**IN THE MATTER of Private Plan Change 100 – Riverhead to the
Auckland Unitary Plan**

JOINT WITNESS STATEMENT (JWS) IN RELATION TO:

Topic: Stormwater and Flooding (2)

Date 5 August 2025

Figure 5: Water surface elevation difference map (post-Pre) – 2YrCC2.1

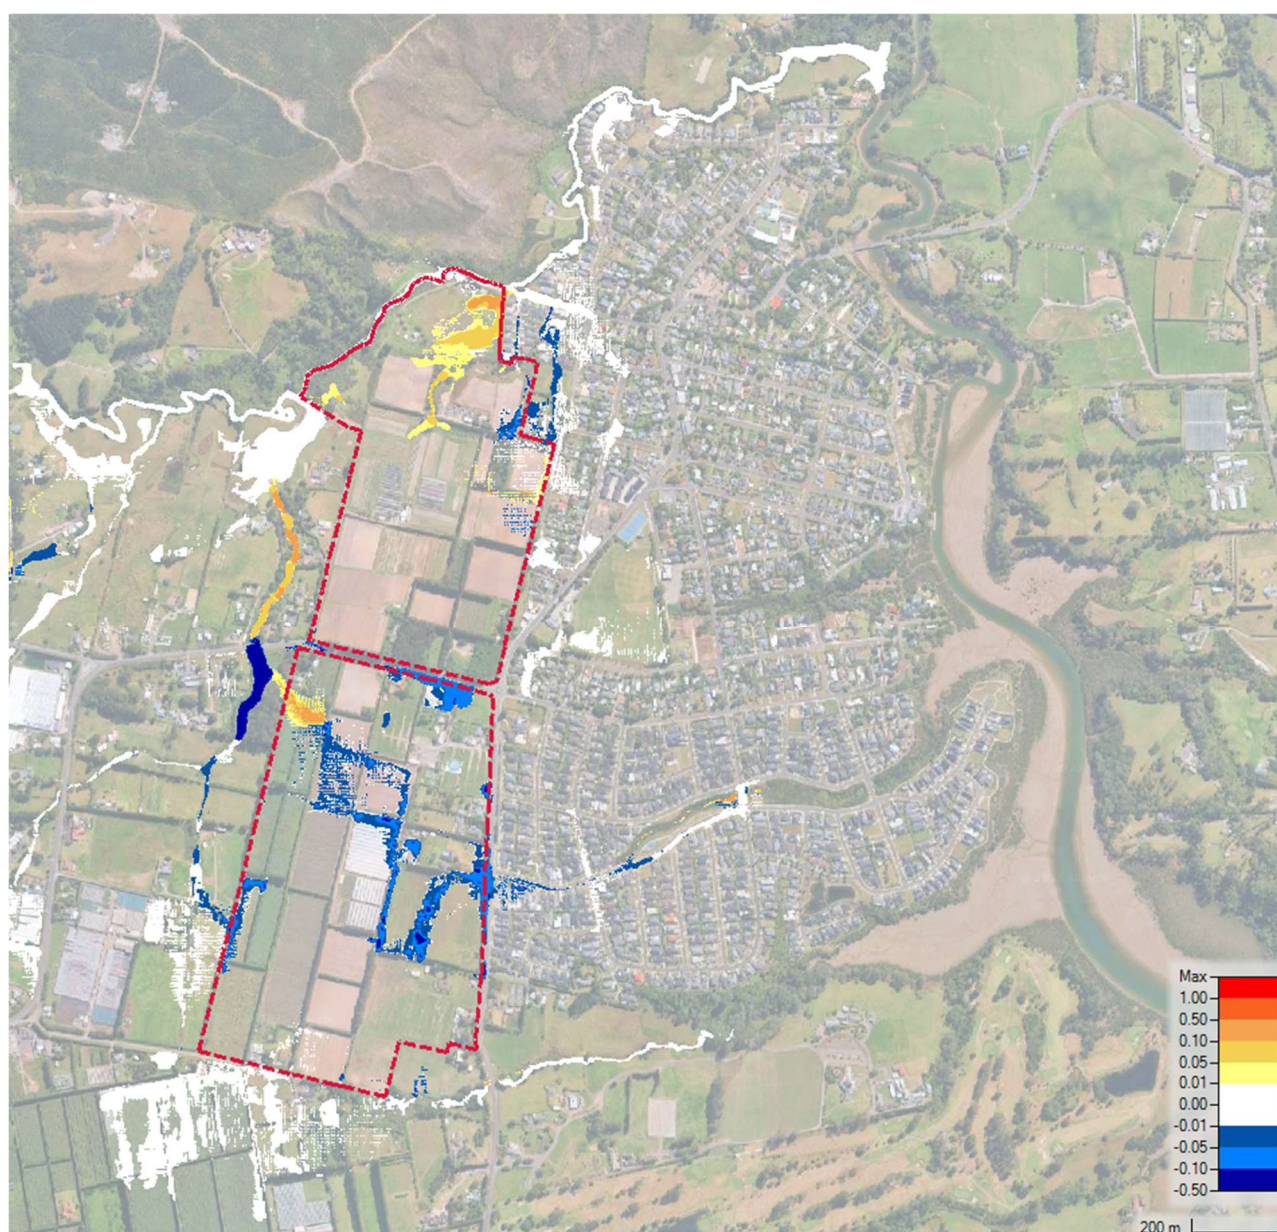
Under the 2yr ARI+2.1°C scenario, noticeable increases (more than 10mm) are observed within RPCC100 area and within the Western Tributary downstream of Riverhead Road culvert as shown in Figure 5 below.

Figure 6: Top water level increases within 22 Duke Street - 2yrCC2.1

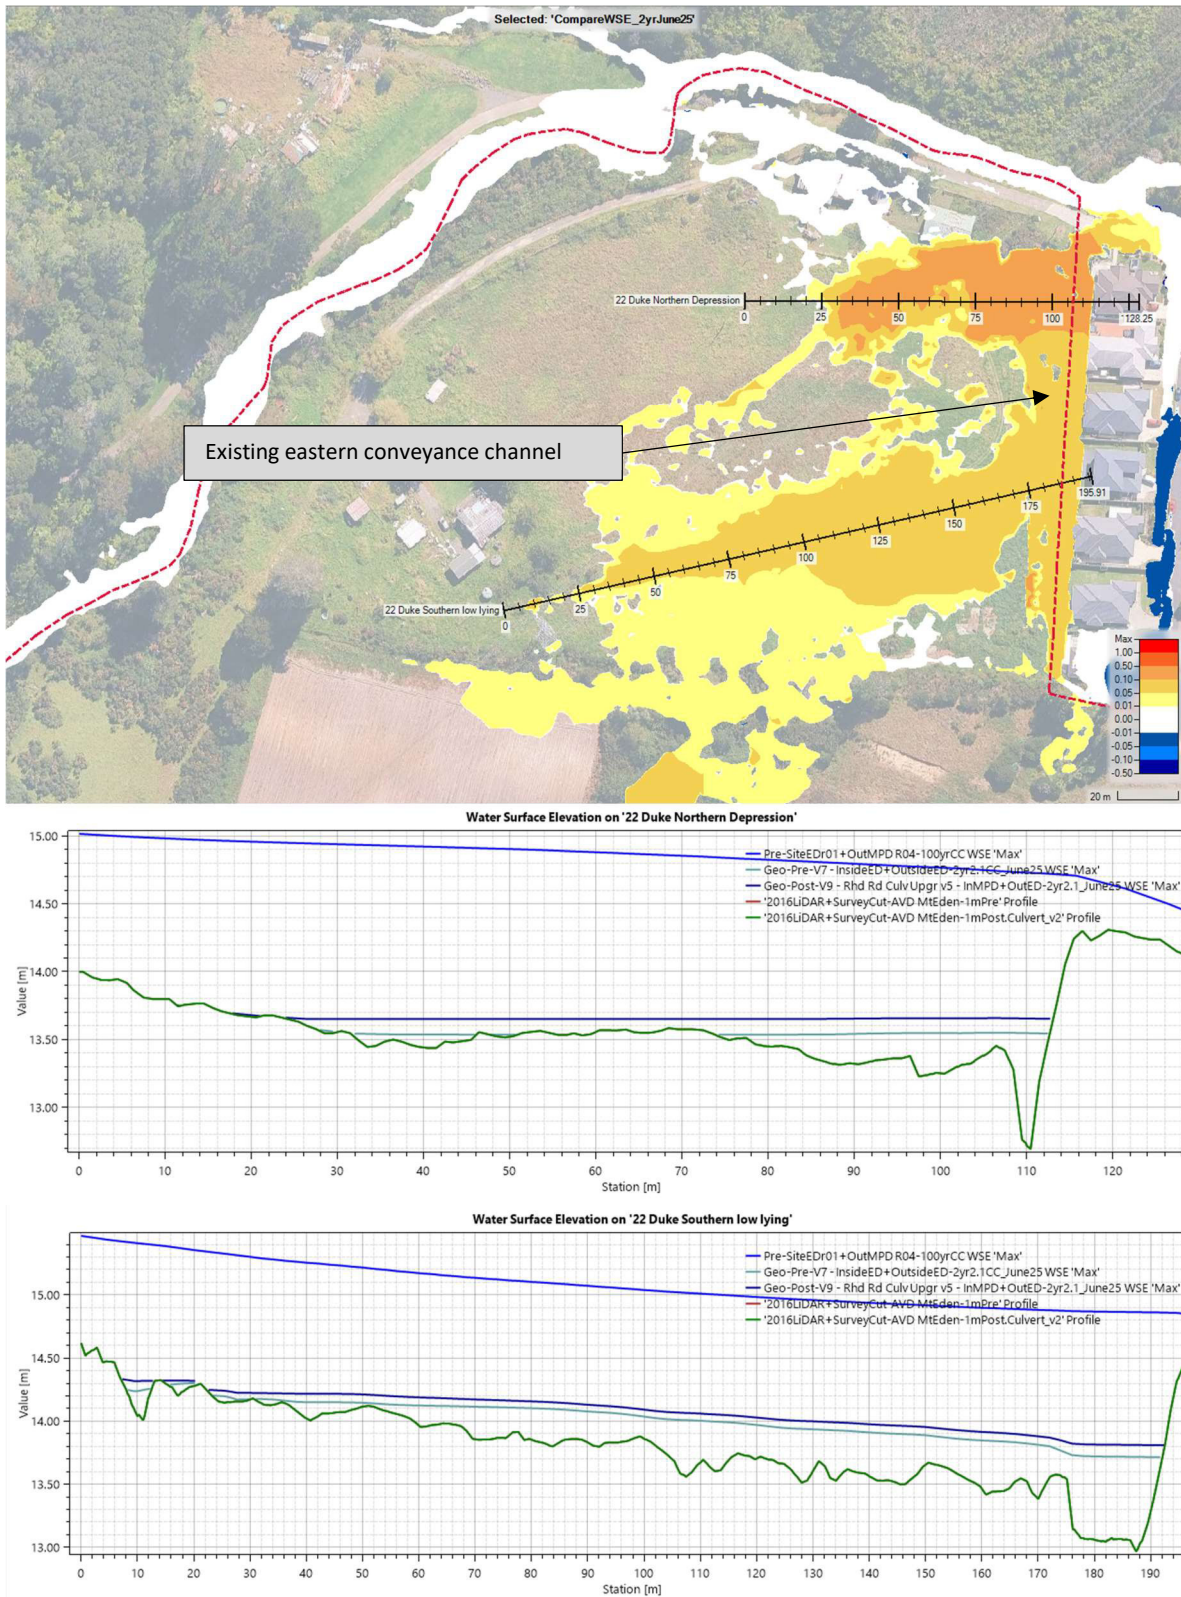
- 3.5.4 SF also notes that 22 Duke Street has been modelled (scenario 12-13) to be subject to more flooding of up to 115mm in the two year storm event with 2.1 degrees Celsius climate change and up to 70mm in the ten year with 2.1 degrees Celsius climate change (noting this is based on ED for all catchment areas outside of PPC100 and no primary network).

- 3.5.5 BR and SF note that once the primary network is included to convey 10 year plus climate change flows (as per the SWCOP v4) downstream of 22 Duke Street the flood modelling should show an improvement. This is subject to detailed modelling to be undertaken at resource consent stage.

The maximum observed increase in top water levels (up to 115 mm) within the RPPC100 area at 22 Duke Street is generally contained within the existing low-lying areas with minimal change to the horizontal extent, as shown in Figure 6 (with the pre-development 100yr+3.8 CC top water level shown for context). The observed increases are considered to be largely due to the fact that the flood model does not contain a primary stormwater system and, as such, all discharges are loaded directly as surface flow. It is common practice, at a plan change level, for a primary stormwater system not to be modelled because it (the stormwater conveyance system) will be subject to detailed engineering that appropriately occurs at resource consent stage.

In reality, once development occurs, the primary stormwater system within the RPPC100 area (including the existing public conveyance channel along the eastern boundary of 22 Duke Street) will be designed/upgraded to collect and convey flows from more frequent events, up to and including the 10yr ARI with climate change allowance, directly to the Forest Stream as required under the Auckland Council Stormwater Code of Practice. This is expected to eliminate the observed top water level increases in this (and other) locations with the RPPC100 area in both the 2yr and 10yr ARI events (including climate change).

Figure 9: Top water level increases within 22 Duke Street - 10yrCC2.1

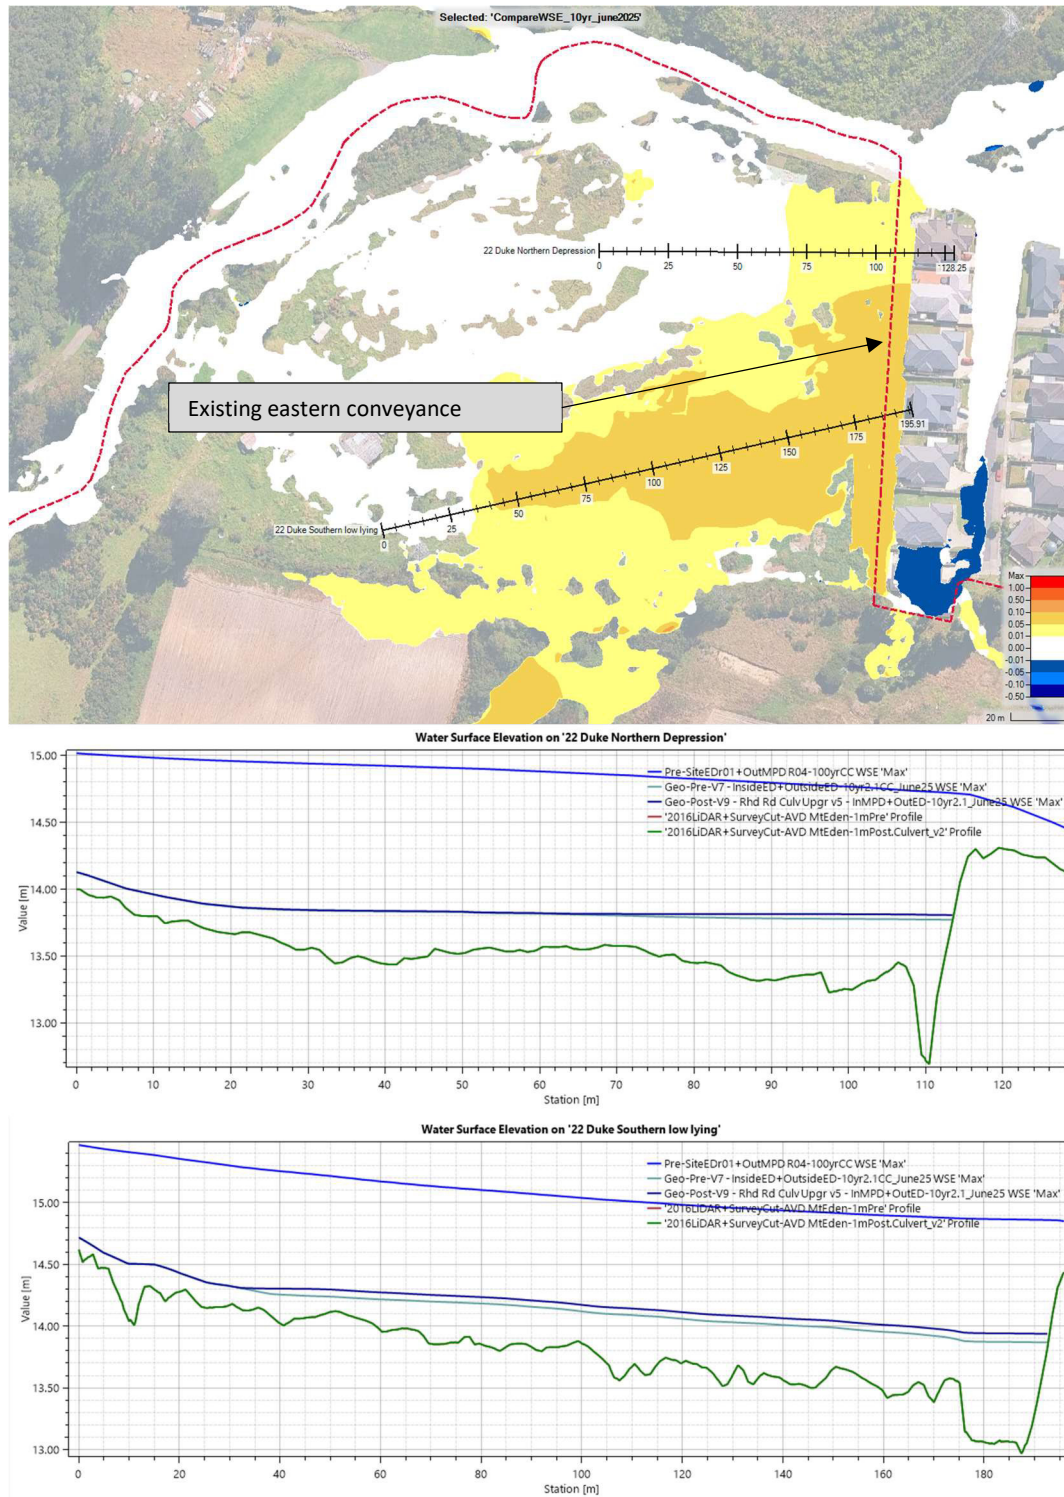
While there are noticeable increases in top water level observed within the RPPC100 area at 22 Duke Street, these are generally contained within the existing ponding areas, with no significant change in extent as shown in Figure 9 with pre-development 100yr+3.8CC shown for context. Additionally, as noted in Section 6.1 above, the observed increases are considered to be largely due to the fact that the flood model does not contain a primary stormwater system, as is appropriate at a Plan Change level of assessment. Once the design of the primary system is undertaken at future design and resource consent stages and included in future modelling, it is expected that the observed top water level increases within 22 Duke Street in frequent events will be resolved.

Figure 10: Water surface elevation difference map (post-Pre) – 100YrCC3.8

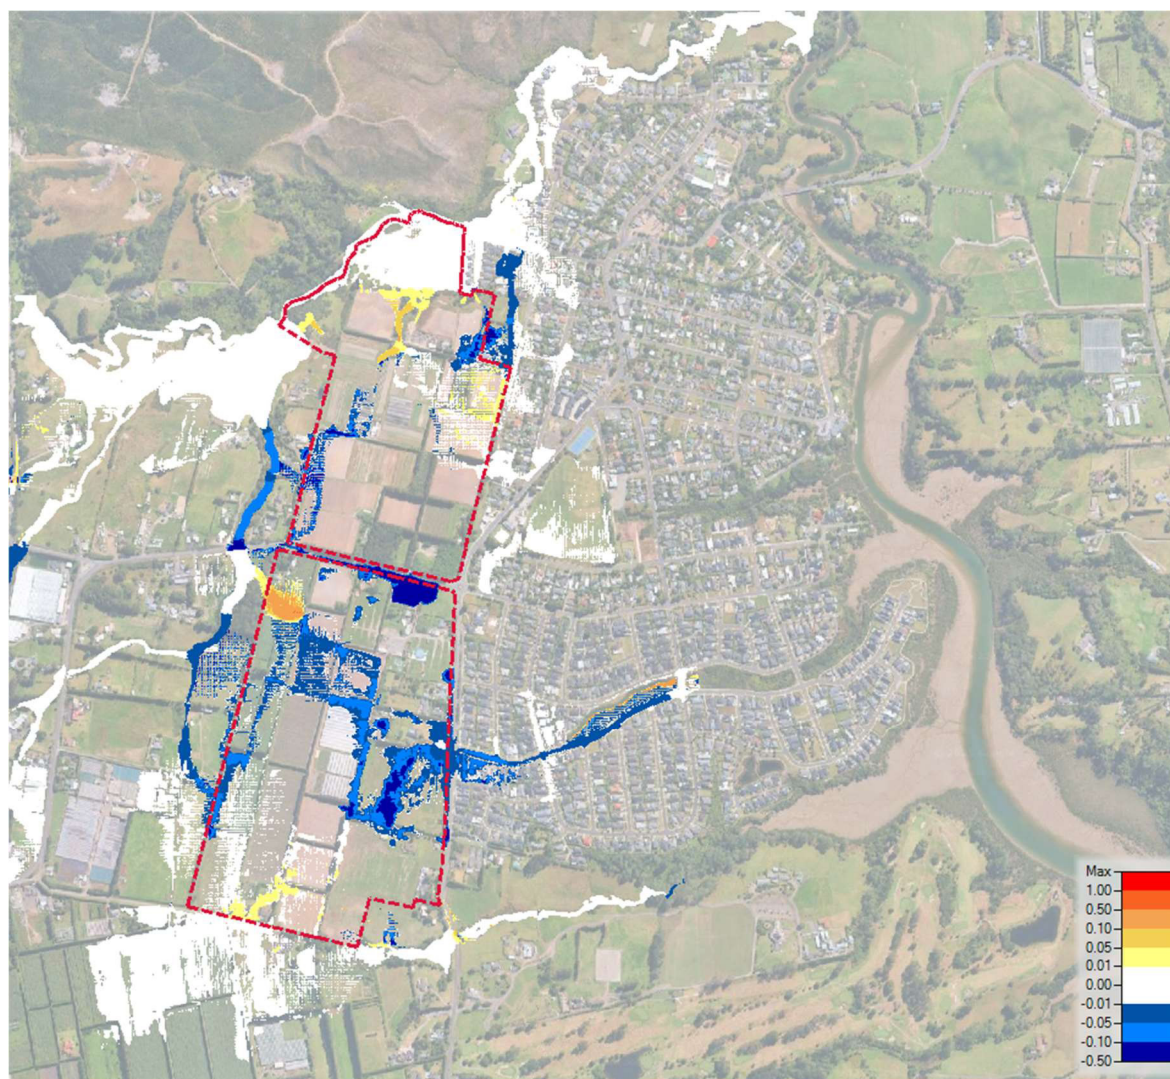
Under the 100yr ARI+3.8°C scenario, noticeable increases in top water level (of more than 10mm) are only observed within the RPPC100 area as shown in Figure 10 below. However, there are several areas outside the RPPC100 area where top water levels show a noticeable decrease, particularly along Cambridge Road.

Figure 12: Top water level increases within 22 Duke Street - 2yrCCWOCC

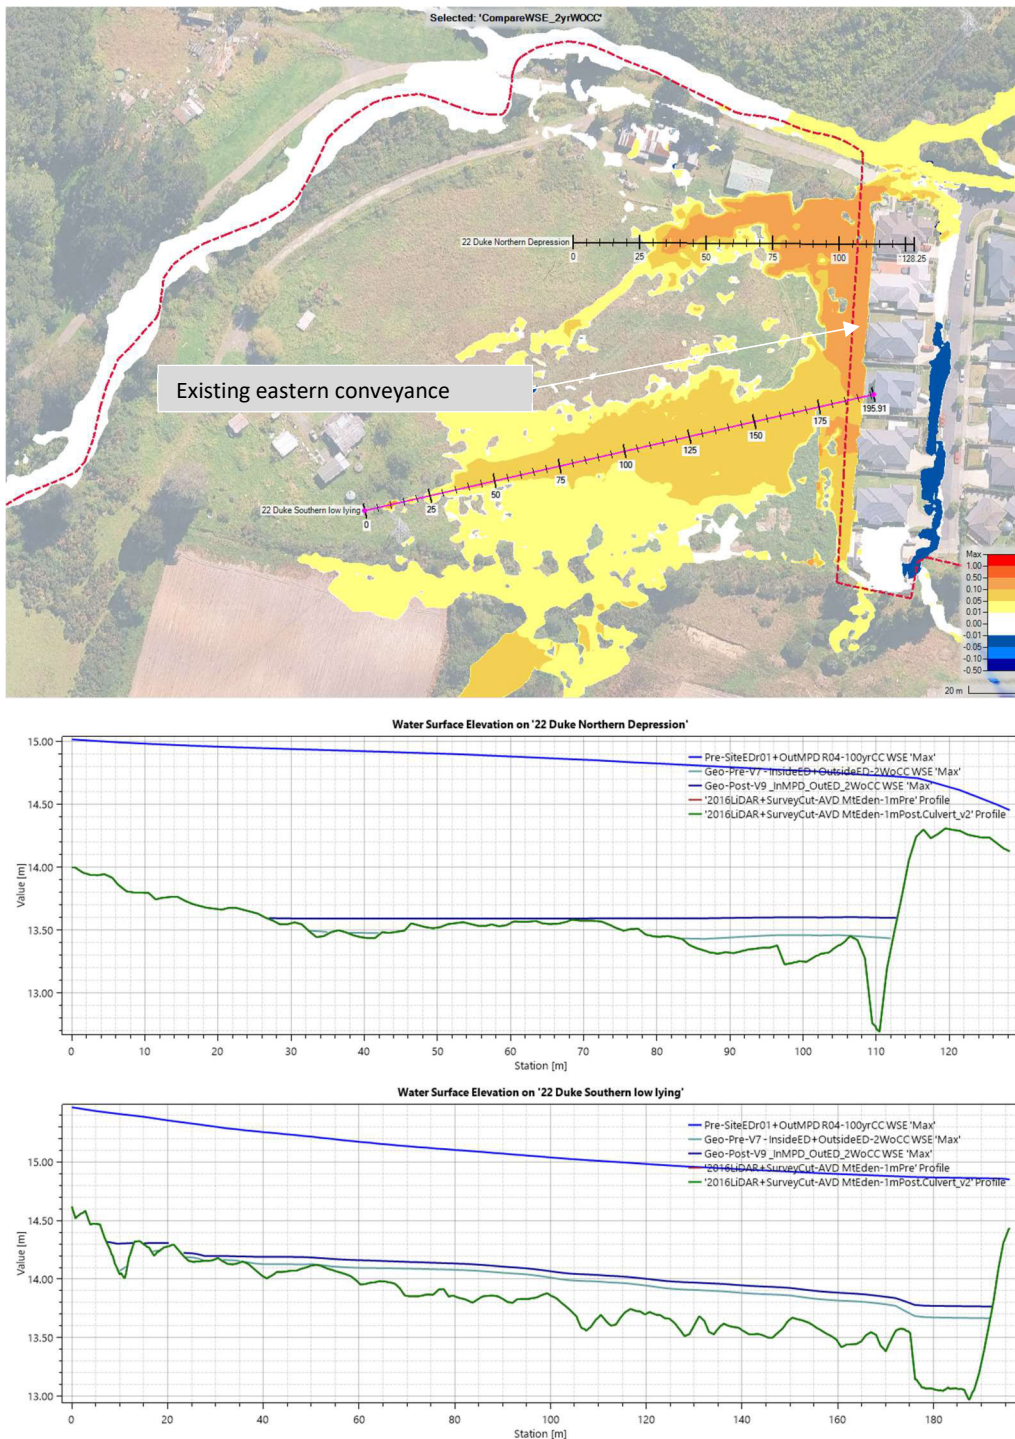
Similar to the results for the 2yrCC2.1 scenario (Scenario 12), the maximum observed increase in top water levels (up to 220 mm) within the RPPC100 area at 22 Duke Street is generally contained within the existing low-lying areas with minimal change to the horizontal extent, as shown in Figure 12 with the pre-development 100yr+3.8 CC top water level shown for context. The increase just beyond the eastern boundary of 22 Duke Street is contained within a channel protected by an easement noted on these properties for surface flow of overland flow. As discussed in previous sections, the observed increases are considered to be largely due to the fact that the flood model does not contain a primary network, and it is expected that these will be resolved through appropriate design of the primary system as the development within the RPPC100 area progresses through consenting phases.

Figure 13: Cross section across the Western Tributary where the increase in top water level is maximum-2YrWOCC

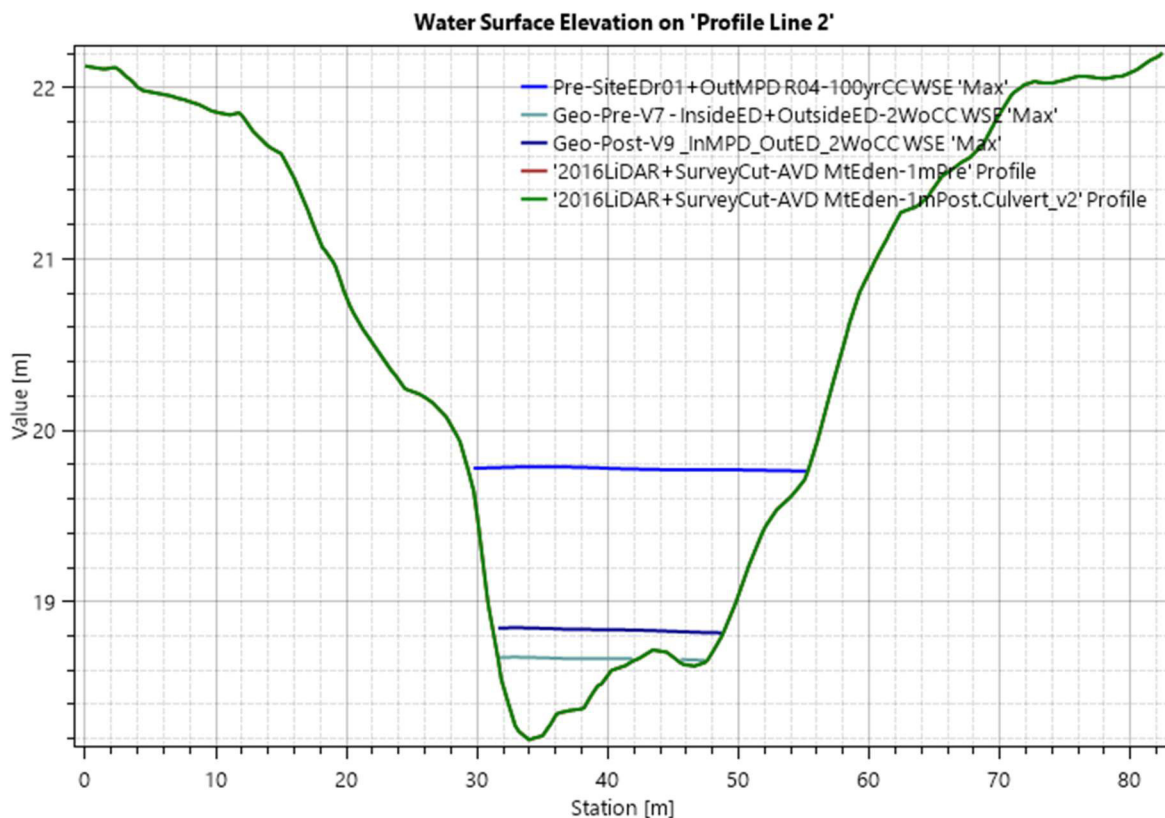
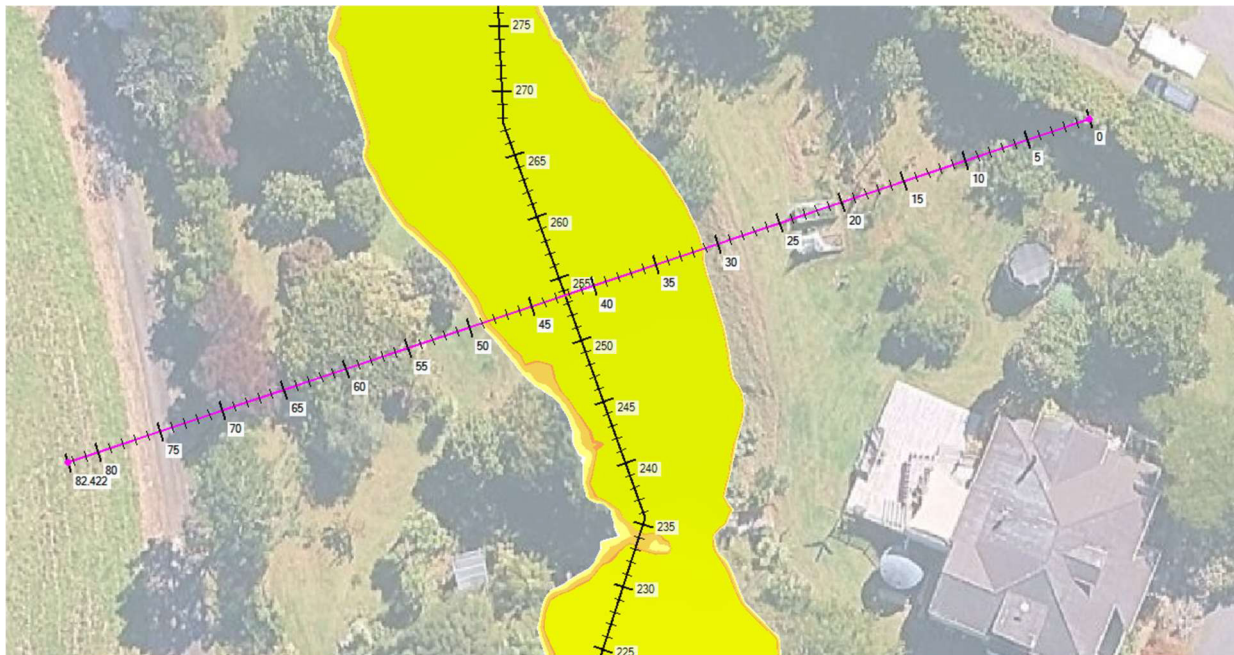
Although there is an increase of top water levels (approximately 250mm max) observed within the Western Tributary downstream of Riverhead Road the increase is (easily) contained within the stream channel, as shown in Figure 13 with pre-development 100yr+3.8CC top water level shown for context, and is considered less than minor. This also applies for the minor (up to 20mm) increase downstream of Duke Street – see Figure 14.
